Planning Committee: 25 June 2025.

Proposed Alteration and Extension of Office Building, Change of Use to Mixed Use Facility, Extension of Car Parking, and Associated Infrastructure and Landscaping at the Orkney Research and Innovation Campus, Stromness.

Report by Director of Infrastructure and Organisational Development.

Application Reference:	23/458/PP.
Application Type:	Planning Permission.
Proposal:	Alter and extend office building (Block 3) including three storey extension with roof terrace, and change of use, to create a mixed-use food and drink (Class 3), office (Class 4) and education (Class 10) facility, install six air source heat pumps, install external wall insulation and air source heat pumps (Charles Clouston Building), reconfigure and construct car parking, install electric vehicle charging infrastructure, associated hard and soft landscaping including construction of a ramp and steps, and install air source heat pumps (Robert Rendall Building).
Applicant:	Mr Harvey Stevenson, Highlands and Islands Enterprise.
Agent:	HRI Munro Architecture, 62 Academy Street, Inverness, IV1 1LP.

Drawing Title
Proposed Site / Block Plan

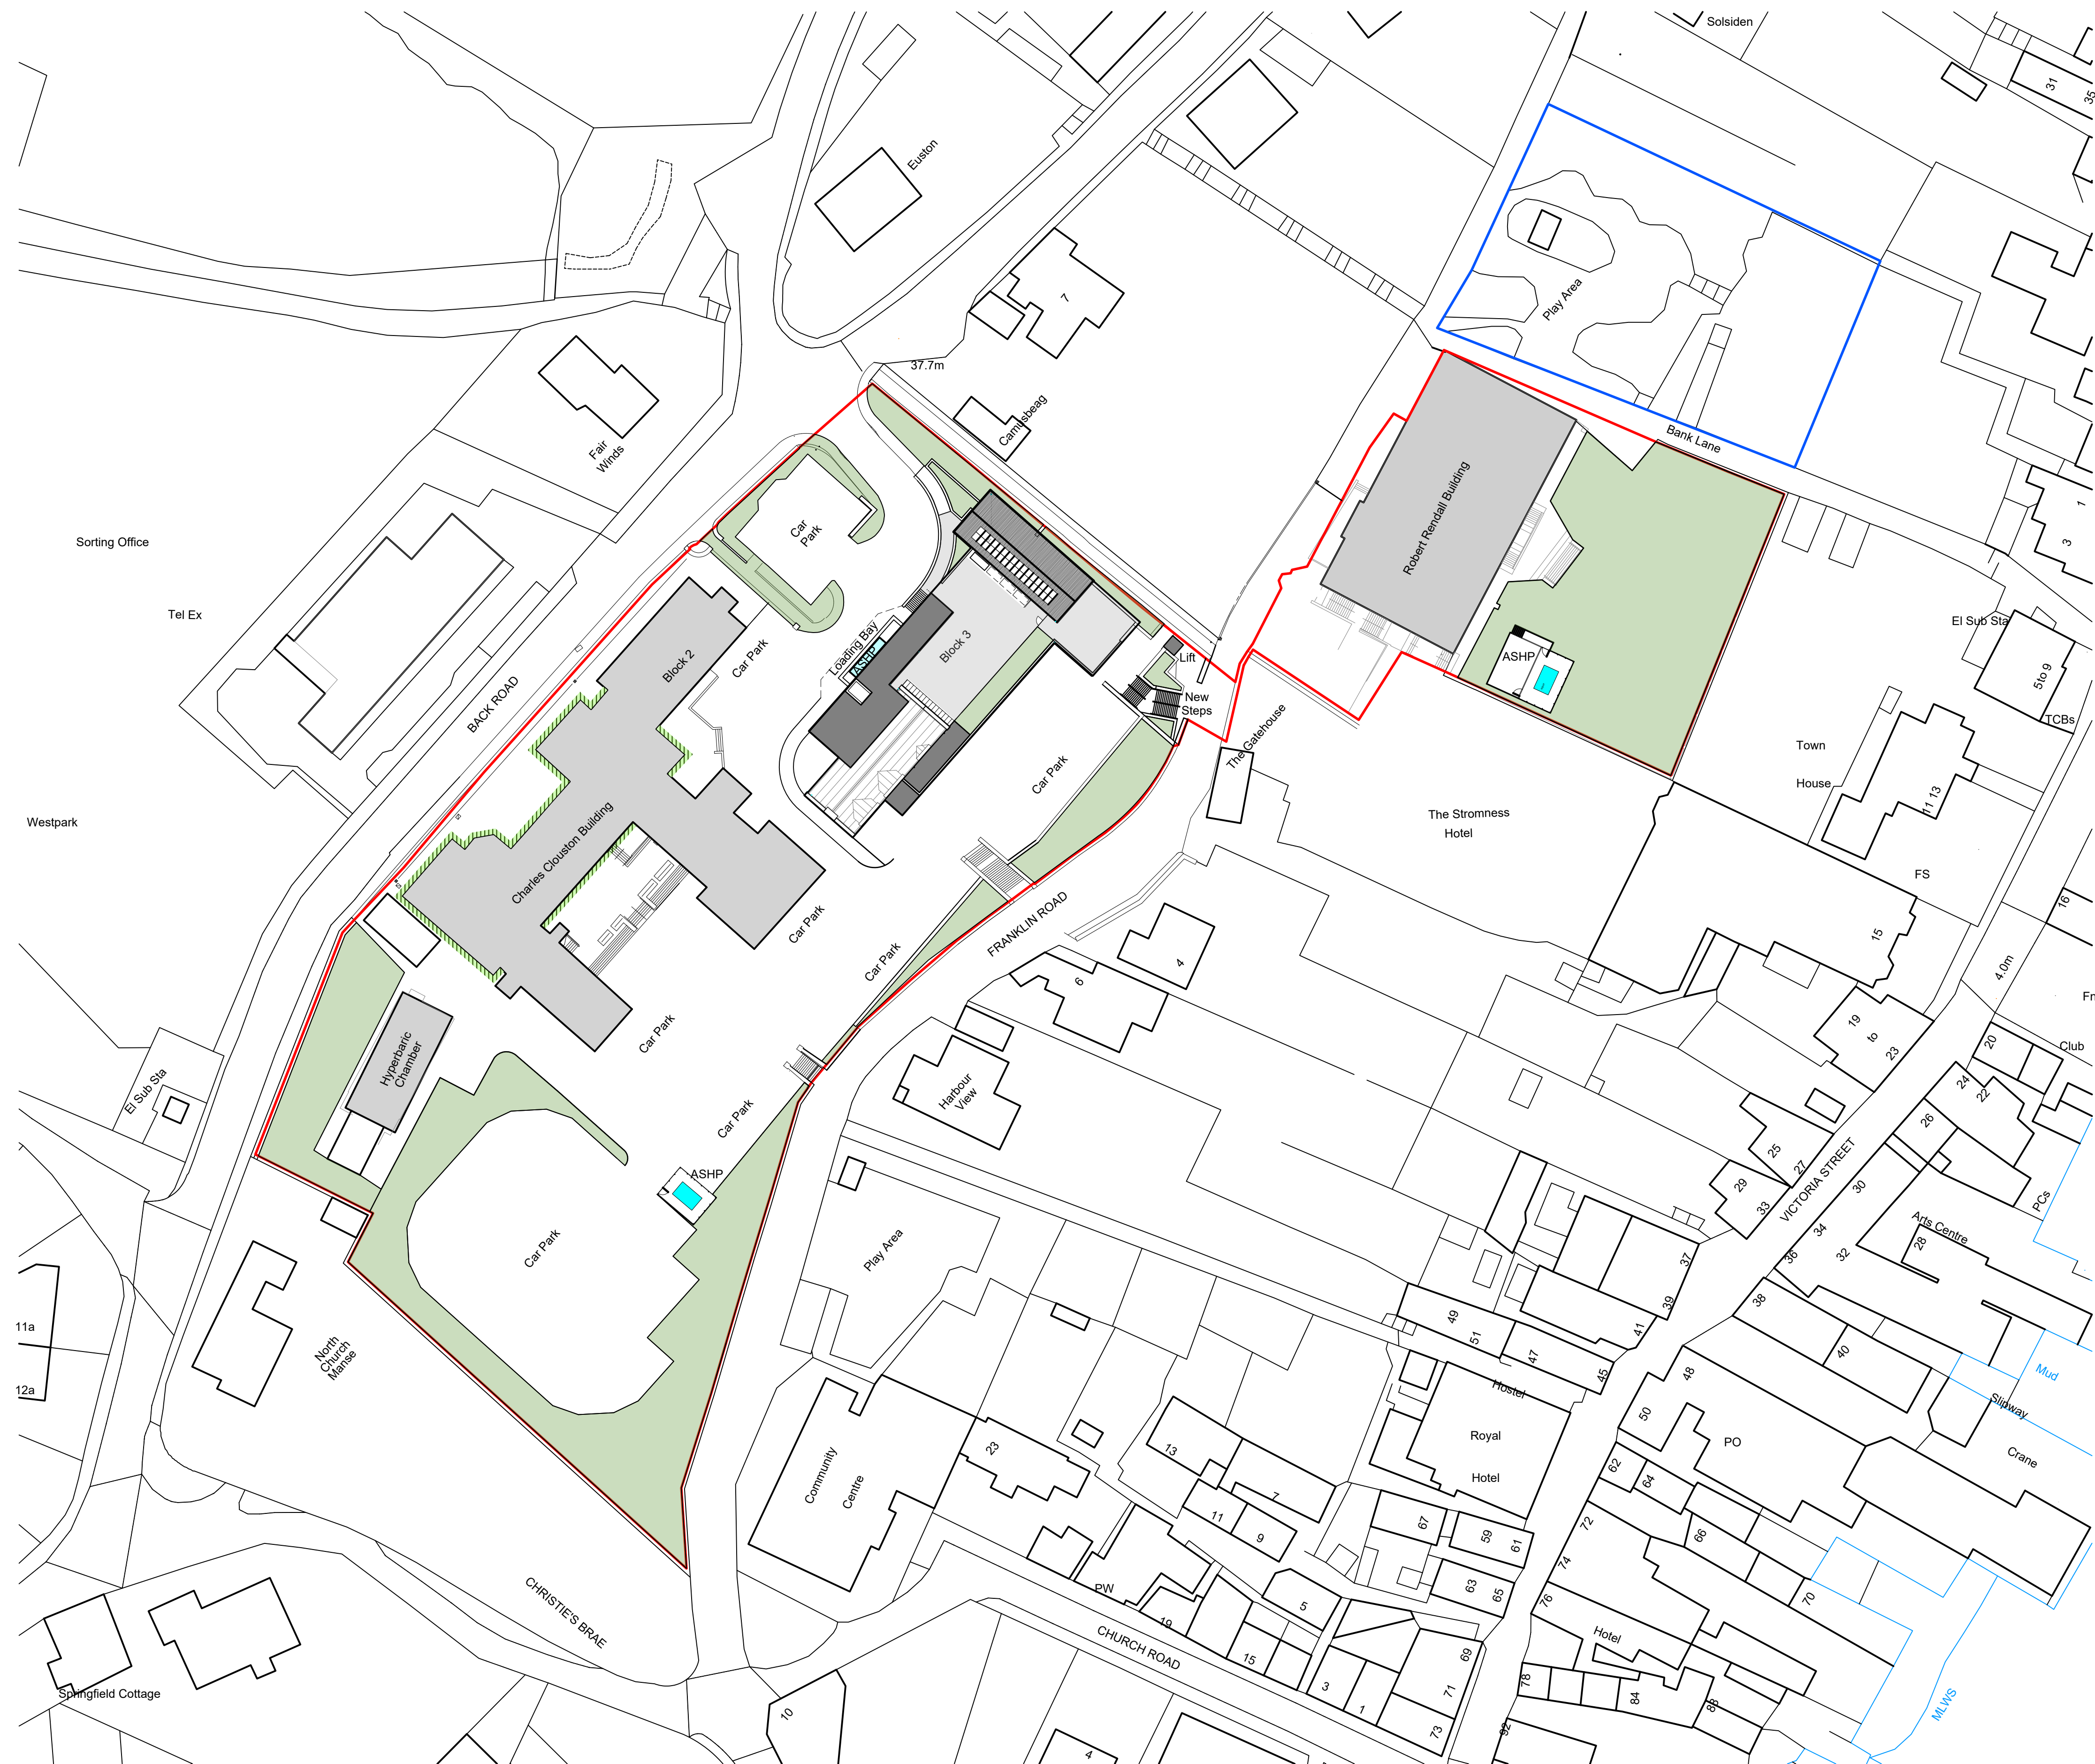
Drawing No T-7294-003 Rev No 4 Proposed Site / Block Plan and the Design statement, Section 4.6, paragraph 4, point 3, indicate 'new landscaped share surface' or 're-surfacing of the roadway', however no detail for either area has been provided. The construction details for the 'Proposed Paved Courtyard + Shared Surface' area indicated must be supplied for further comment.

05. Notwithstanding the car park layout included in the site plan hereby approved, no development shall commence until full details of the layout of the car park has been submitted to and approved, in writing, by the Planning Authority, in conjunction with Roads Services. These details shall include the layout of parking bays for both the existing and additional car parking, pedestrian walkways/routes within the car park, and lighting proposals which shall include street lighting columns. Thereafter, the development hereby approved shall not be brought into use until the car park is laid out wholly in accordance with approved details.
